## Document Update Notification

**TITLE:** EMERGENCY ACTION LEVEL  
CLASSIFICATION

**CHANGE NO:** 037-02-0

**ENTERGY OPERATIONS INCORPORATED  
ARKANSAS NUCLEAR ONE**

**Attachment 8 (0CNA080005)**  
**Unit 2 Fuel Cladding Failure Radiation Plot**  
**mRem/hr at 2TCD-19**

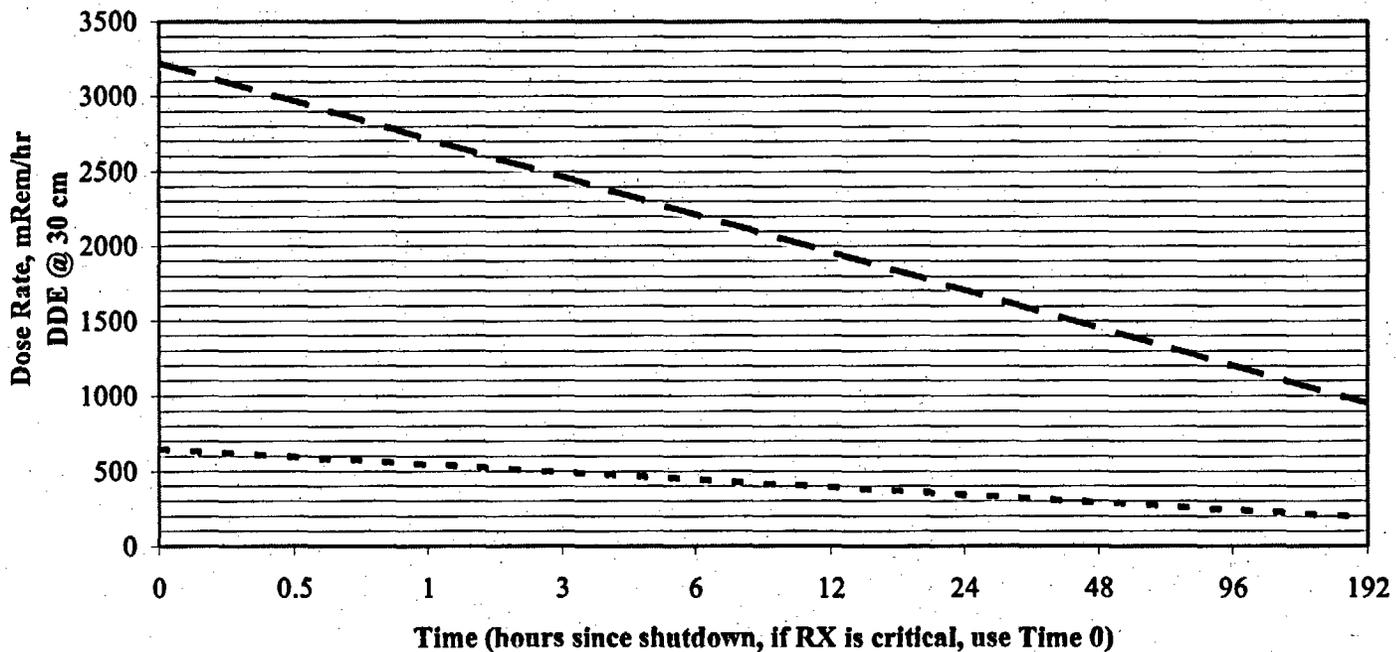
Added note "If RX is critical, use Time 0" to graph to give the operators guidance for usage of the graph.

**NOTE: If RX is critical, use Time 0**
